Project	IEEE 802.16 Broadband Wireless Access Working Group < http://ieee802.org/16 >
Title	Details of SDD Section 11.9.2.5 Bandwidth Request Channel
Date Submitted	2008-09-05
Source(s)	Fan Wang, Weimin Xiao, Bishwarup Mondal, Amitava Ghosh, Mark Cudak, Fred Vook Motorola E-mail: fanw@motorola.com
Re:	SDD Session 56 Cleanup, Call for PHY Details
Abstract	This is revised version of Section 11.6 of IEEE 802.16m-08/003r4. This document provides further physical layer details.
Purpose	Draft for further development of the IEEE 802.16m SDD
Notice	<i>This document does not represent the agreed views of the IEEE 802.16 Working Group or any of its subgroups. It represents only the views of the participants listed in the "Source(s)" field above. It is offered as a basis for discussion. It is not binding on the contributor(s), who reserve(s) the right to add, amend or withdraw material contained herein.</i>

Details of SDD Section 11.9.2.5 Bandwidth Request Channel

11.9.2.5 Bandwidth Request Channel

Figure 1 Bandwidth Request Procedure

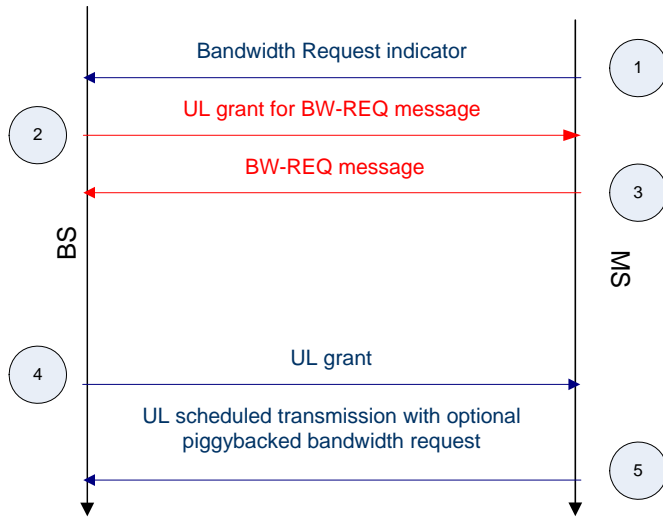
The random access bandwidth request procedure is described in Figure 1. A 5-step regular procedure (step 1 to 5) or an optional quick access procedure (step 1,4 and 5) may be supported concurrently. Step 2 and 3 are used only in 5-step regular procedure. In step 1, MS sends a bandwidth request indicator that may indicate bandwidth request from MS, and the BS may allocate uplink grant based on certain policy. The 5-step regular procedure is used independently or as fallback mode for quick access procedure. The MS may piggyback additional BW-REQ information along with user data during uplink transmission (step 5).

Deleted: information such as MS addressing and/or request size (FFS) and/or uplink transmit power report (FFS)

[Figure 2. Non-contention based bandwidth request channel pilot and data Tone allocations](#)

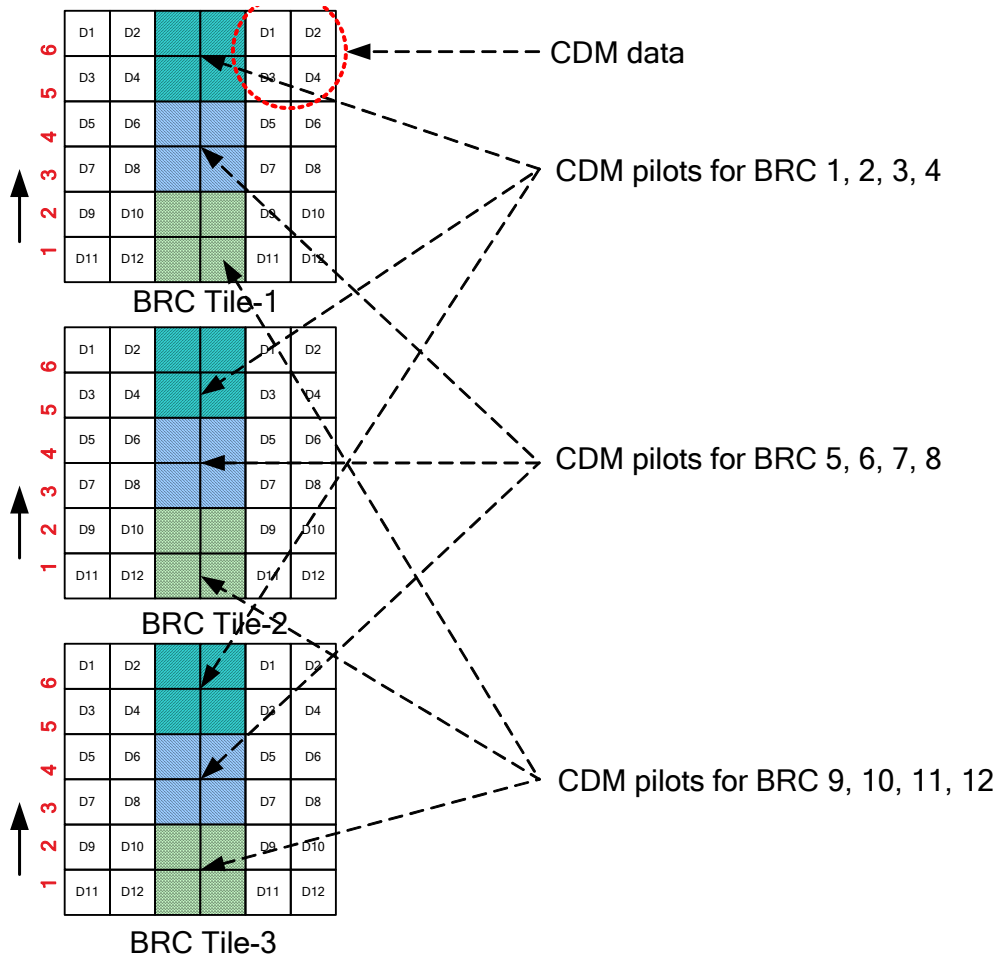
8 For non-contention based bandwidth request channels, twelve UL bandwidth request channels are multiplexed
9 together using a mixture of FDM/TDM/CDM in three UL DRU tiles. For each group of four tones that are
10 adjacent in time and frequency, pilot and data symbols from four bandwidth request channels are CDMed
11 together in order to take full advantage of the MS transmit power. Further, since these four tones are adjacent
12 in time and frequency, orthogonal codes can be used to separate the four bandwidth request channels. Finally,
13 multiple groups of four tones are allocated in each tile with FDM/TDM. The pilot and data tone allocations are
14 shown in Figure 2.
15
16

Figure 3. [Non-contention based bandwidth request tile allocations](#)

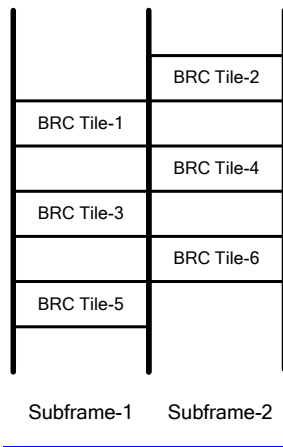
[In order to improve the coverage of bandwidth request channel for cell edge MSs, the bandwidth request tiles are allocated in time dimension first as shown in Figure 3. Further, subframe based frequency hopping of the tiles can be applied to improve the frequency diversity.](#)
